Bayside Planning Panel

Item No	6.5
Application Type	Section 96 Application – Residential Flat Building
Application Number	DA-2013/56/03
Lodgement Date	24 November 2017
Property	13A Church Avenue, Mascot Lot 1 in DP 547700
Owner	A & S & S Mohebbaty
Applicant	A & S & S Mohebbaty
Proposal	Section 96(2) Application to modify Development Consent No. 13/56 to increase and alter the design of the building in respect of apartment size, car parking, and unit mix, to increase FSR and height, review Section 94 contribution and deletion of level 3 basement.
No. of Submissions	6 (six) objections
Cost of Development	N/A
Report by	Olivia Yana, Acting Senior Development Assessment Planner

Planning Assessment Report

Figure 4. Proposed Modifications

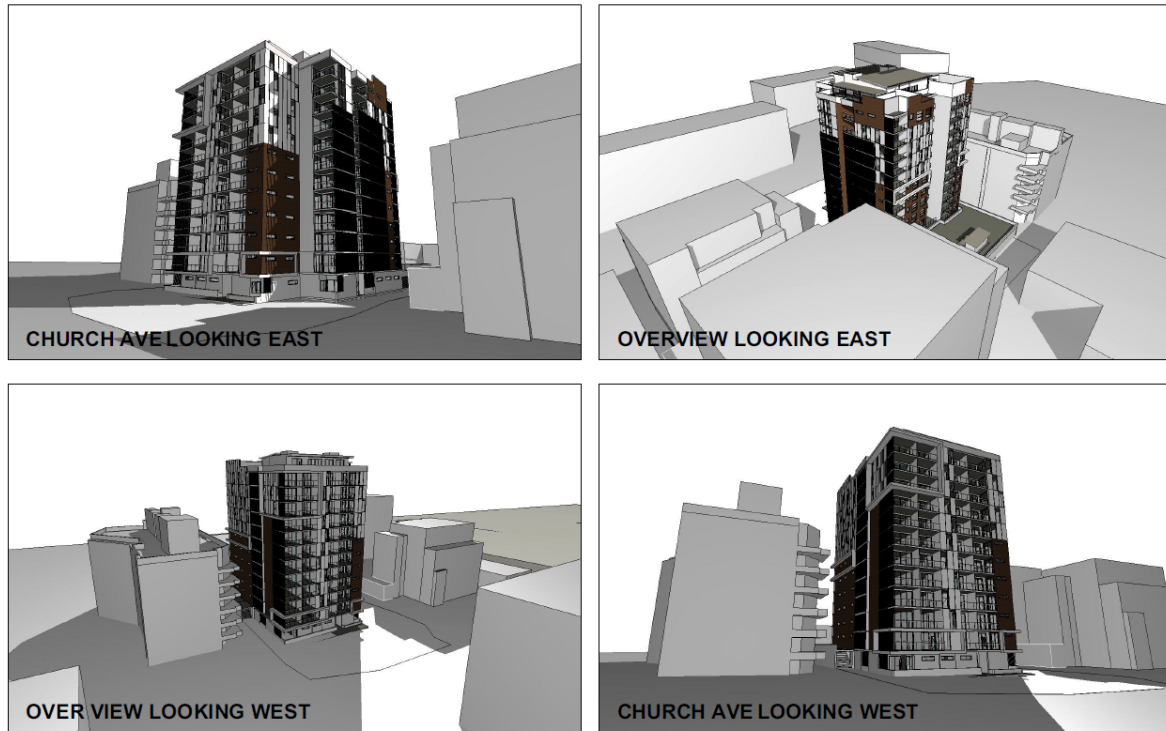
- Increase the size of communal room on the roof top;
- Delete basement (Level 3) and reduce the number of car parking spaces from 138 to 110;
- Increase all floor levels including ground floor level from RL 7.44 AHD to RL 7.59 AHD, floor to ceiling height of the ground floor from 3.35 metres to 3.5 metres, and floor to ceiling height of typical floor level from 3 metres to 3.1 metres. The floor level increases consequently raises the building height as measured to the roof top floor level by 1.1 metres from RL 43.94 AHD to RL 45.04 AHD;

- Delete condition requiring roof mounted solar collector on the roof top, which was required for hot water to the units;
- Increase height of lift over run from 3 metres to 4.6 metres;

Figure 8. Photographs taken by the Assessing Officer standing from the middle of level 11 balcony of 214-220 Coward Street adjoining to the main living room

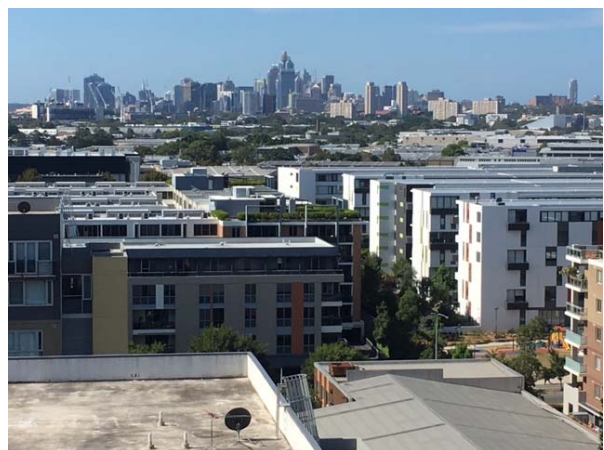
Council's Assessing officer has also visited the site to understand the view and carry out the view loss assessment. The photographs taken from by the assessing officer in Figure 8 from standing in the middle of the balcony adjoining to the main living room.

Figure 9. Additional bulk on South Elevation highlighted in yellow

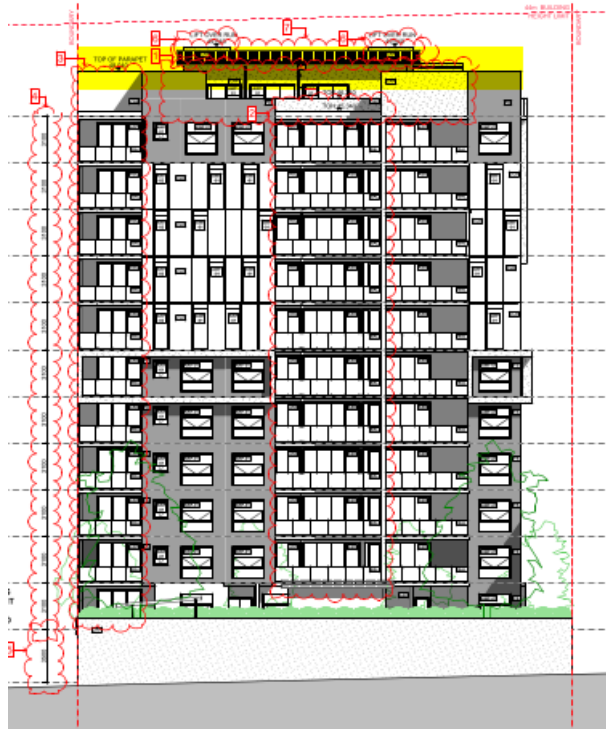
The view analysis provided by the applicant in Figure 7 is based on an angled view photograph taken from the objectors' property situated on level 11 at 214-220 Coward Street while standing on the edge of the balcony adjoining to the main living room. The view analysis does not clearly identify the differences between the approved and proposed development as the analysis is provided on an angled perspective. The proposed additional height of 2.7 metres that is almost equivalent to an entire new level has not been demonstrated on the view analysis. The bulk and scale of the entire building and not just the roof top/level 13 are actually increased. While the modification to height is lower than the maximum applicable height for the site as stipulated within the BBLEP 2013, the main bulk of the building has been raised by 1.1 metres, refer to Figure 9 above.

While it is imminent that the existing city skyline could not be entirely protected due to the location of the approved development and the objector's property, the reasonableness of the proposal causing impact is not considered to be acceptable. As discussed above, even though the proposed modification will comply with the maximum height permissible on the site, the main bulk of the building could have been reconsidered. The fourth step of the view loss assessment stated that with a complying proposal, the question should be asked whether a more skilful design could provide the applicant with the same development potential and amenity and reduce the impact on the views of neighbours. In this circumstance, additional articulation could have been further applied on the proposed south elevation of the plant rooms

Figure 10. Shadow Diagrams Winter Solstice 9am (L), 12pm (Middle) & 3pm (R)

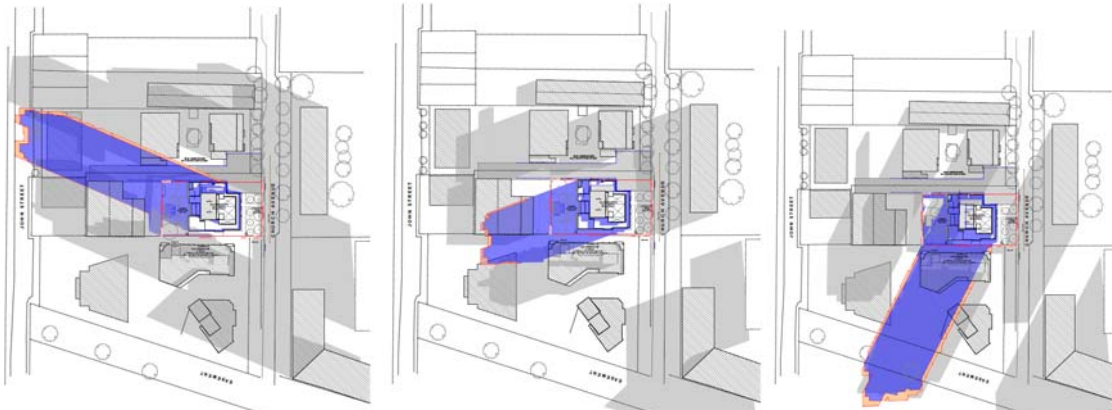
Due to the additional bulk and scale proposed, additional overshadowing will result from the development. However, due to the orientation of the site and approved height of the building, the additional shadow will be mainly cast on the adjoining streets, refer to Figure 10 below.
